From: Tessa way
Sent: Monday, 15 February 2016 7:03 AM
To: records
Subject: DA0658/2015

>>
>> General Manager,
>> Launceston City Council,
>> 15.2.2016
>>
>> Re: Planning Permit DA0658/2015
>> 13 Olive St.
>> Newstead
>>
>> Att. George Walker
>>
>> We would like to lodge an objection to the above permit.
>> Our objection is to the building of an in ground pool.
>>
>> Points of our objection follow.
>>
>> 1. The excavation of the pool could compromise our retaining brick wall, paving and garden. The level of the yard at 13 Olive St is a metre higher than ours and the bordering fence sits on this elevated position.
>>
>> 2. Any rupture of the pool or leakage would drain directly into ours and our neighbours yard. Our neighbour at 7/28 Landsborough Ave.
>>
>> 3. The plans do not show the position of the pump for the pool.
>> We believe noise from the pump and filter unit would be intrusive. The same property currently has an intrusive air con unit.
>>
>> 4. Further to our objection we support the objection of _____ as the proposal for the house extension would invade her privacy.

Objection to DA 0658/2015 13 Olive Street, Newstead

Front, Side & Part Rear Yard Privacy Lost

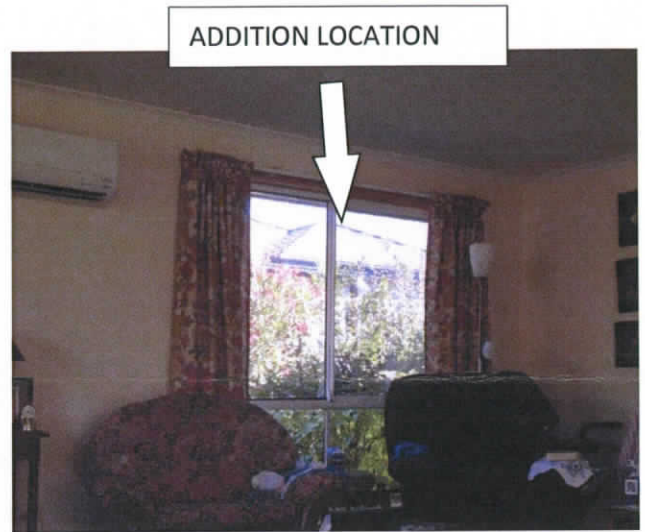
The north and east facing window that wraps around on 2 sides from the proposed new first floor Sitting Room/Bedroom has a setback of 5.3m from my side boundary. This window may be offset by 1.5m from the windows on my dwelling, however the wrap around nature of this window and its low height in the wall (much lower than 1.7m sill height), means that the 1.5m offset does not minimise the significant impact on privacy that this window (and also the narrow stairwell window) has on my property.

The fact that this wrap around window has a larger 5.3m setback does in fact give it a more panoramic and wider view over my property, still at close quarters and thus causes a more severe impact on my privacy and thus the amenity of my property.

Direct View into my Living Room

Arrows denote views over my front, side and part rear yards and into my bedroom & living room

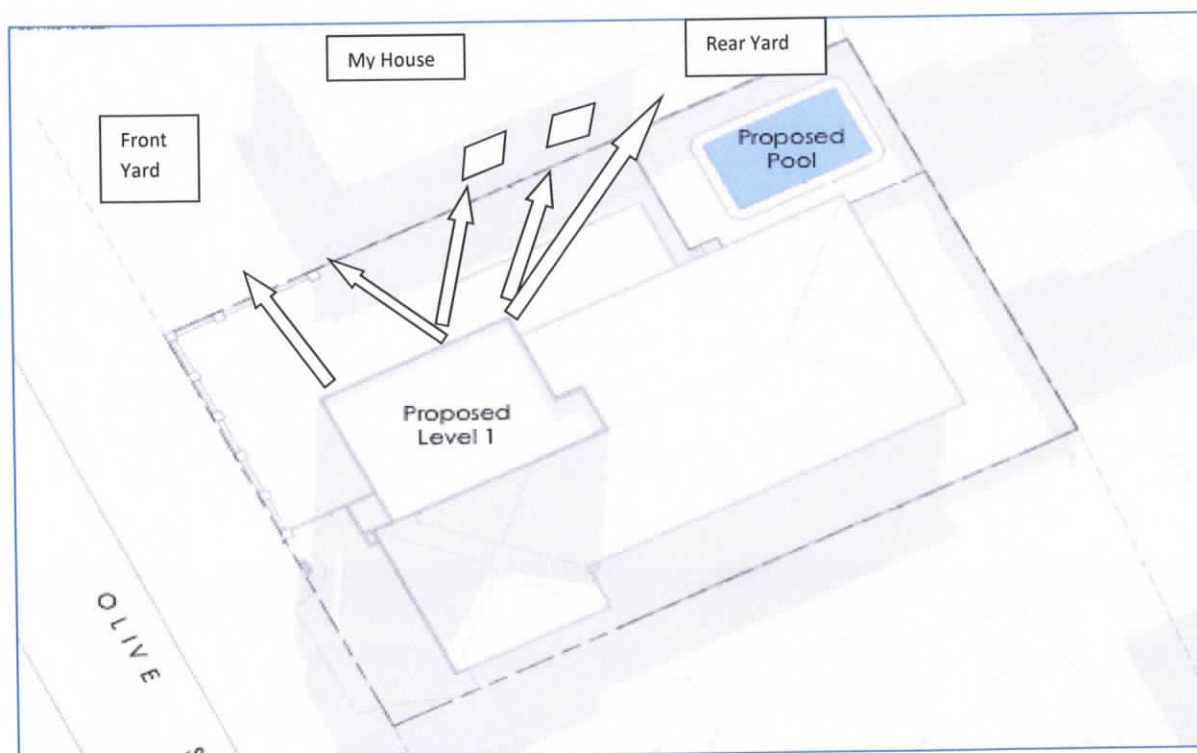
The proposed building staircase to the first floor addition (i.e. narrow high window) does not minimise direct and focused overlooking over the entire front yard of my property.

The proposed building first floor addition does not minimise overlooking into the living room window of my property.

The north and east facing window that wraps around on 2 sides from the proposed new first floor Sitting Room/Bedroom has a direct view into my bedroom and main living area windows and has a direct view over my side garden private open space. In all cases these direct close clear views are within a 9m distance and are worse than horizontal views but more like views from a platform above.

The proposal should have included, at a minimum, window bottom sill heights starting at 1.7 metres for the north and east facing window that wraps around on 2 sides from the proposed new first floor Sitting Room/Bedroom and no staircase window.

As indicated above - This window may be offset by 1.5m from the windows on my dwelling, however the wrap around nature of this window and its low height in the wall (much lower than 1.7m sill height), means that the 1.5m offset does not minimise the significant impact on privacy that this window has on my property.
